Subject: Approval of Change Order No. 1 with Dan Hart Patrol Service, LLC for the Landfill Cell No. 7 Project No. 2112, for an increase of \$440,156.56, for a new contract price of \$2,233,491.38.

CHANGE ORDER NO.: 1

Owner:	City of Watertown	Owner's Project No.:	2112
Engineer:	Houston Engineering Inc.	Engineer's Project No.:	7716-0020
Contractor:	Dan Hart Patrol Service, LLC.	Contractor's Project No.:	
Project:	WRLF Cell 7 Construction

Watertown Regional Landfill Cell 7

Maple Grove	Drawn by AMZ	Date 12-14-2021	WATERTOWN REGIONAL LANDFILL CELL 7 CONSTRUCTION PLANS CITY OF WATERTOWN, SOUTH DAKOTA	LEACHATE COLLECTION PIPE CELL 7 PROJECT NO. 7716-0020	SHEET 7
		P: 763.493.4522 F: 763.493.5572	Checked by DDM	Scale AS SHOWN

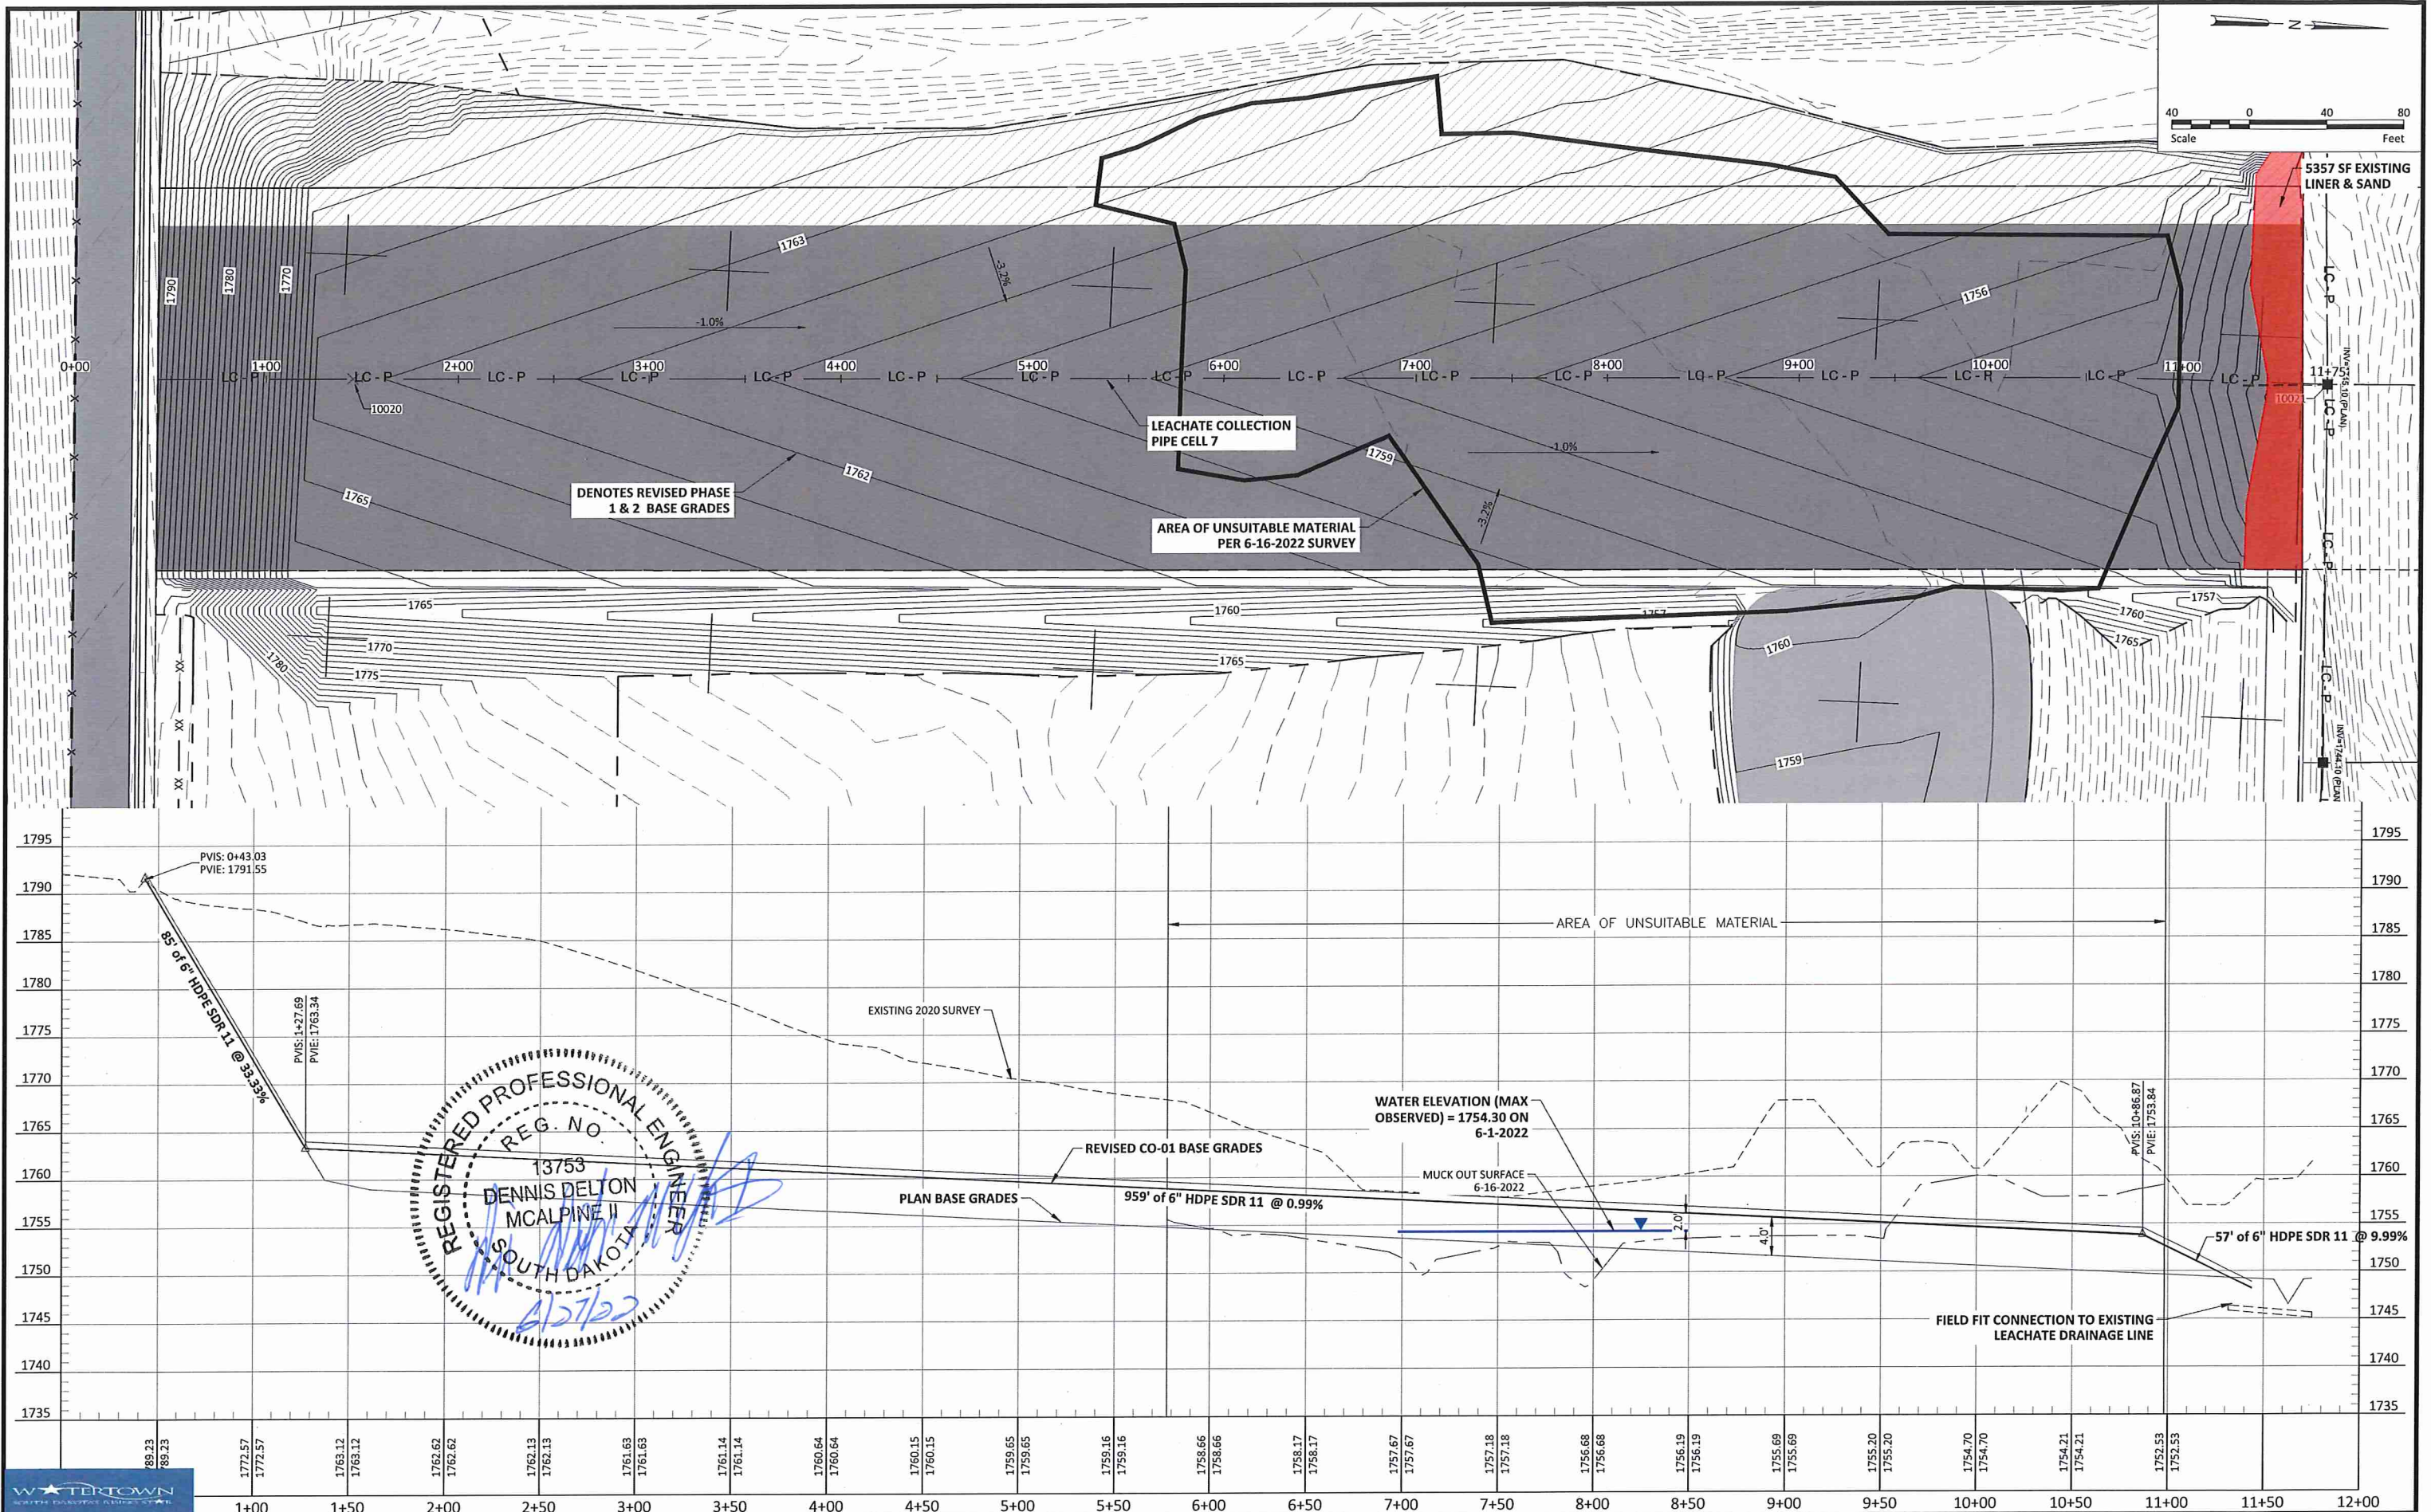
- B. Excavation operations associated with the development of Cell 7 uncovered a significant volume of unsuitable soil materials within the construction area. These materials and the associated wet/saturated conditions were not observed with the construction of the previous landfill Cells (1-6) at the facility. The elevation(s) of the unsuitable materials discovered in Cell 7 is consistent with the base grade elevation(s) of adjacent Cells.

The unsuitable materials, predominately consisting of organic non-compactable soils, were highly saturated upon discovery. The materials were located a few feet below existing grades and extended to depths well below the proposed sub-cut of the Cell 7 base liner system. The unsuitable materials were removed to provide a stable base to place fill materials. To provide separation from the exposed subgrade (excavated base) and allow for construction operations to proceed the base grades of Cell 7 were raised four (4) feet. This grade raise allowed for construction to proceed simultaneously with dewatering activities to "bridge" the area of unsuitable soil removal. The work was completed for a unit price of \$9.59/CY. This price exceeds the contract unit price by \$1.46 per CY (\$9.59 – \$8.13). This increased rate was necessary as result of the changed site conditions requiring materials to be excavated and trucked as opposed to removed and replaced with scrapers.

1	REVISIONS PER SD DANR REGULATORY REVIEW	2-10-2022	AMZ	I hereby certify that this plan, specification, or report was prepared by me or under my direct supervision, and that I am a duly Licensed Professional Engineer under the laws of the State of South Dakota. Dennis D. McAlpine License No. 13753	Date
2	REVISED CELL 7 BASE GRADES PER FO-03/CO-01	6-8-2022	AMZ		
3	REVISED CELL 7 BASE GRADES PER CO-01	6-23-2022	AMZ		
No.	Revision	Date	By

In total 24,542 CY (verified via survey) of unsuitable materials were excavated. An additional 14,905 CY of materials were replaced within the construction area to establish the raised base grades. This work was also completed at the \$9.59/CY price as the conditions (placement methods) were similar to the removal effort(s). Minor adjustments to the contract specified volumes for Common Excavation and Re-Compacted Soil Barrier Layer were necessary to account for Common Excavation that was not required in areas that had not been excavated and those areas excavated to the original subbase grades four (4) feet lower than identified in Field Orders #3 - #5. The work identified for the unsuitable soil removal and associated replacements for Change Order #1 was completed for **\$334,510.08**.

SHEET
17

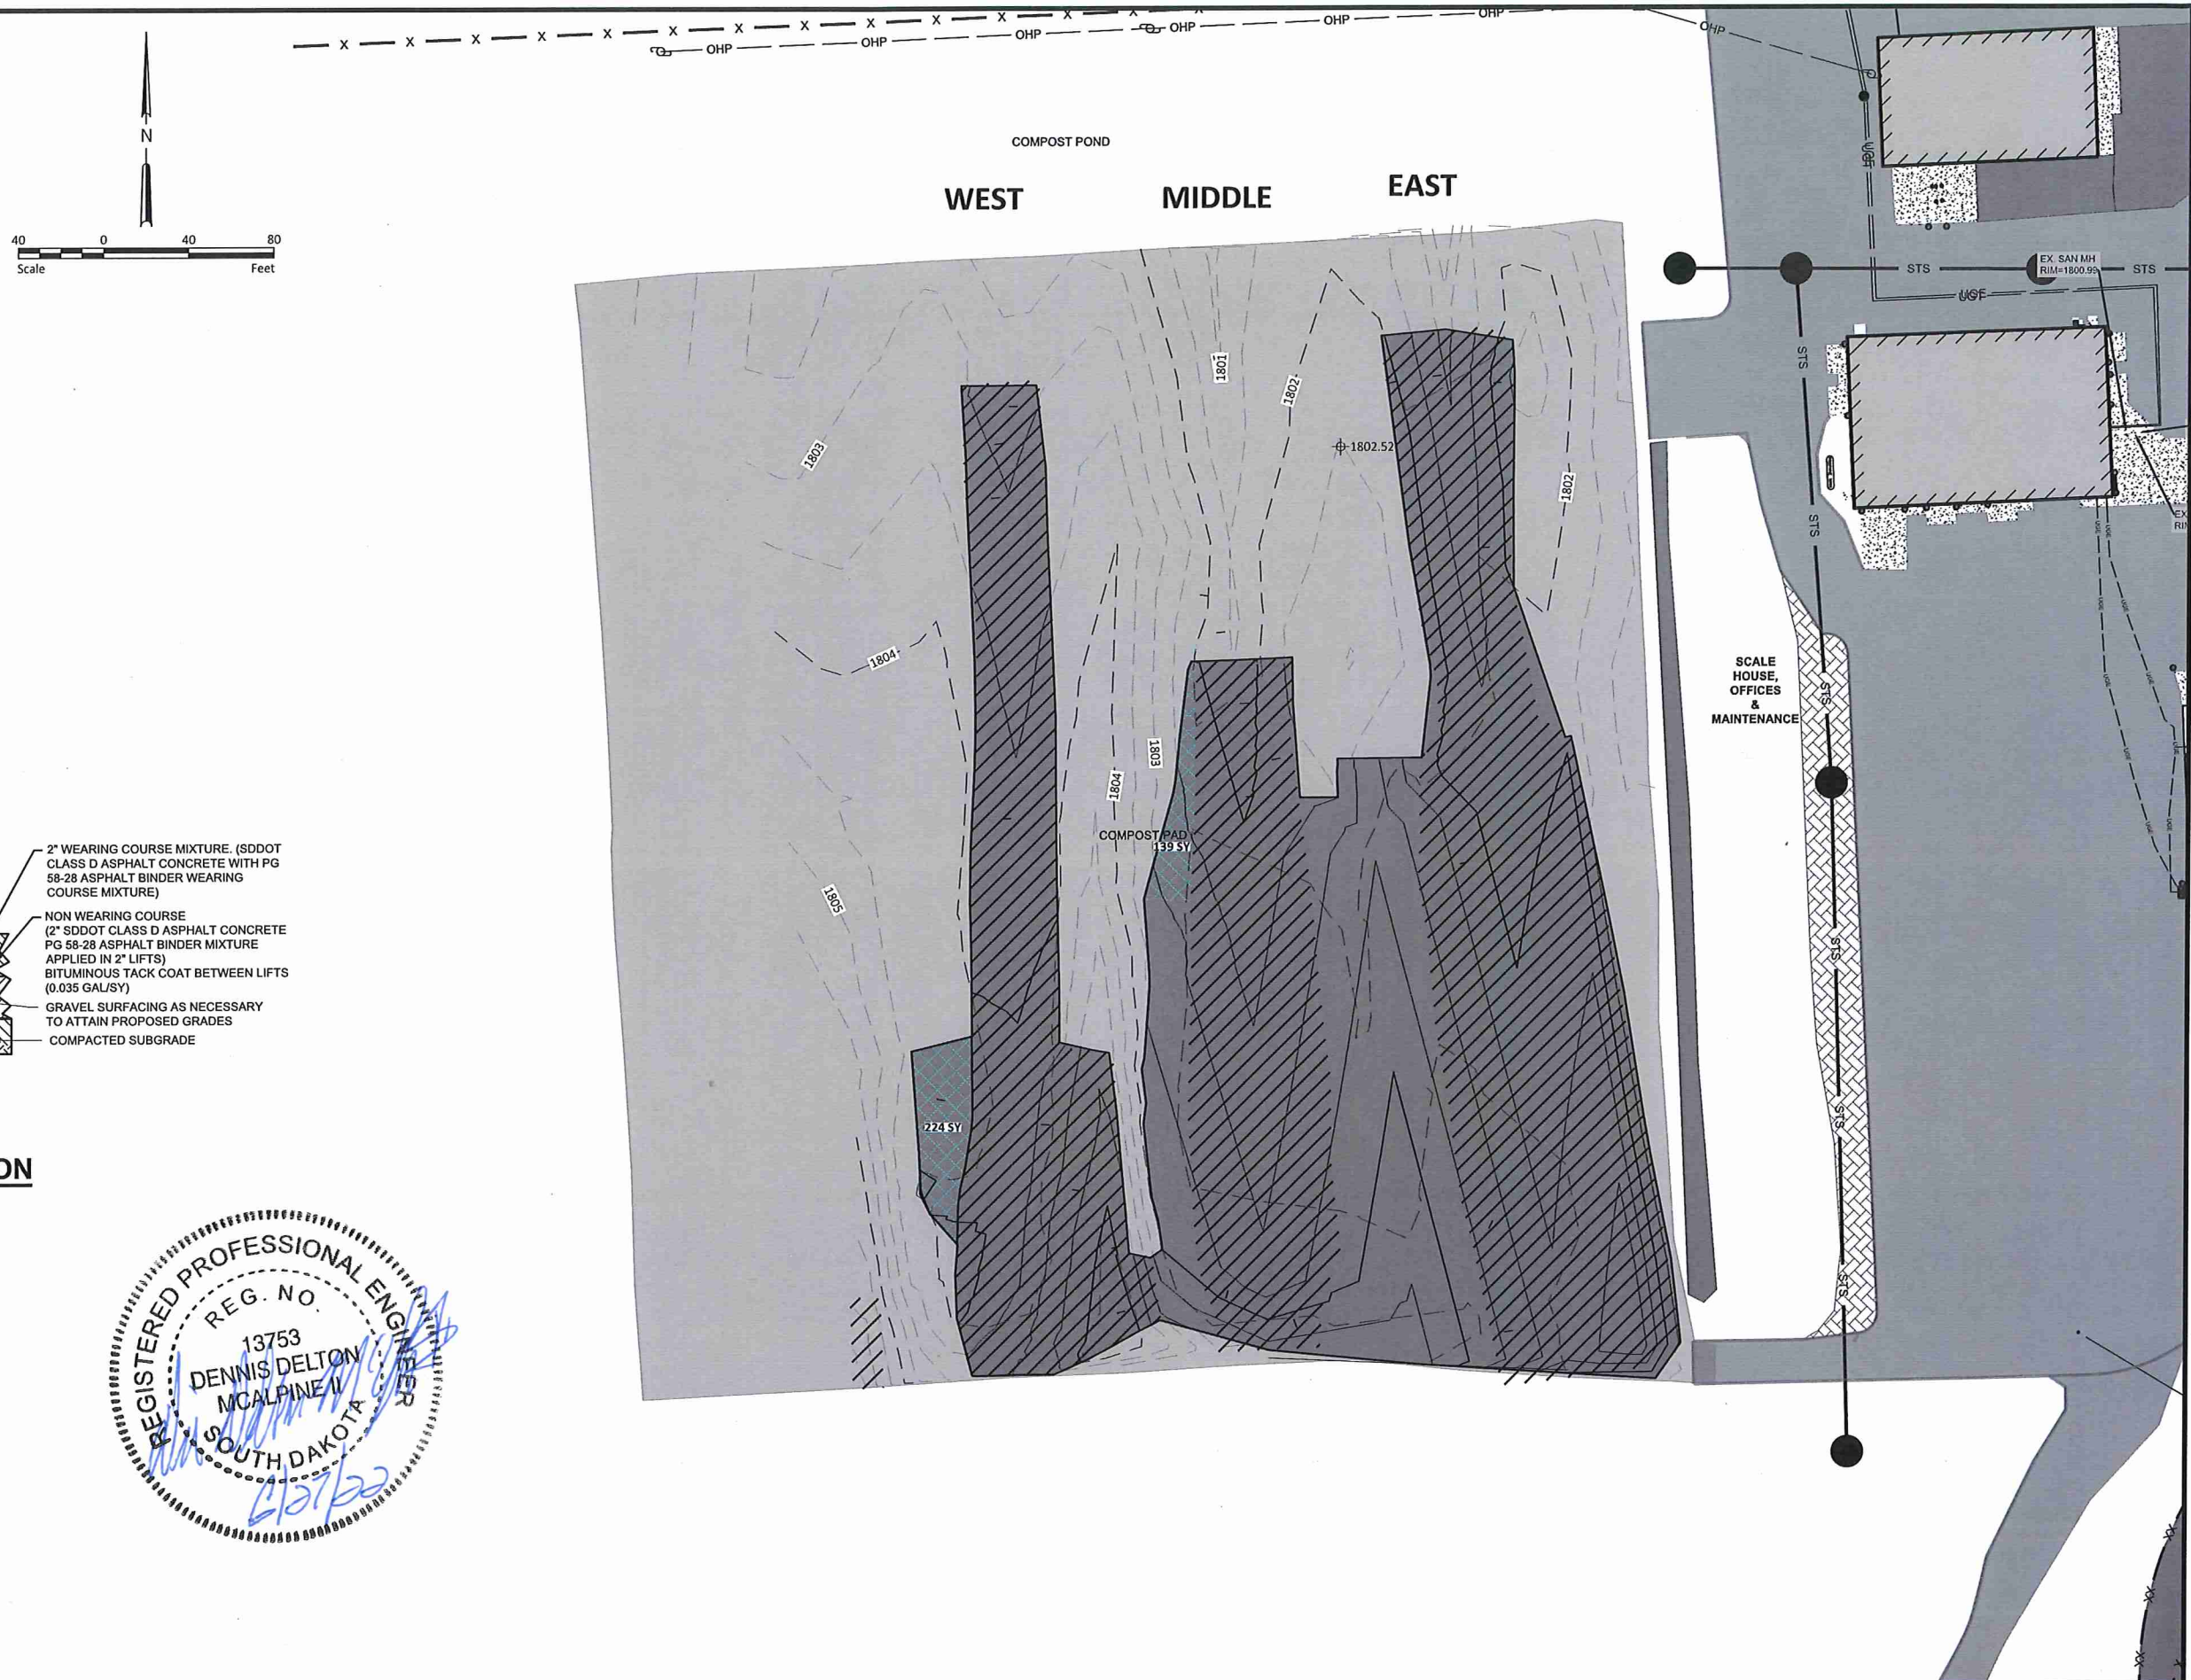
This revised field order (Rev 1) provides direction/understanding for minor work associated with additional bituminous removals & saw-cutting. This field order identifies the placement (fill) of gravel surfacing materials within the plan identified bituminous removal areas and the area between the east and middle compost trench/drainageways. Additional bituminous paving will be required to construct this field order and promote positive drainage (south to north) in the three (3) eastern most compost pad trenches/drainageways with a proposed minimum grade of 0.4%. The additional items for gravel surfacing, saw-cutting, bituminous removals and paving will be paid via the contract specified unit pricing. This field order assumes the gravel materials identified in Contract Item #31 will be used in addition to the plan identified gravel for the compost pad rehabilitation. A summary of the anticipated quantities to facilitate this field order is identified in an attached pdf.

- A. The proposed grades anticipated for the compost pad required significant redesign to accommodate for grade changes (additional settlement) on the south side of the pad. The additional settlement occurred after the City provided survey data was collected and utilized for design. As noted in Field Order 1 (Rev 1) additional pavement materials were removed to accommodate for the connection of proposed (revised) design grades. Field Order 1 (Rev 1) identified the placement of gravel fill materials to raise the grade on portions of the compost pad. The additional gravel fill necessitated additional bituminous paving to provide a hard non-erosive surface. This work has yet to be completed. The contractor has struggled to compact the proposed gravel materials as result of the soft/wet subbase which consists of old (pre-Subtitle D) municipal solid waste. If compaction efforts of the gravel materials are unsuccessful the Contractor will likely need to place a geotextile fabric material to "bridge" the unsuitable subgrade. Cost associated with placement of a geotextile fabric are not included in this change order. The work, if necessary, will be provided in a future change order. A detailed summary of the anticipated costs is included in the attached Change Order #1 Cost Summary Sheet. The work identified for the compost pad for Change Order #1 will be completed via contract unit pricing = **\$105,646.48**.
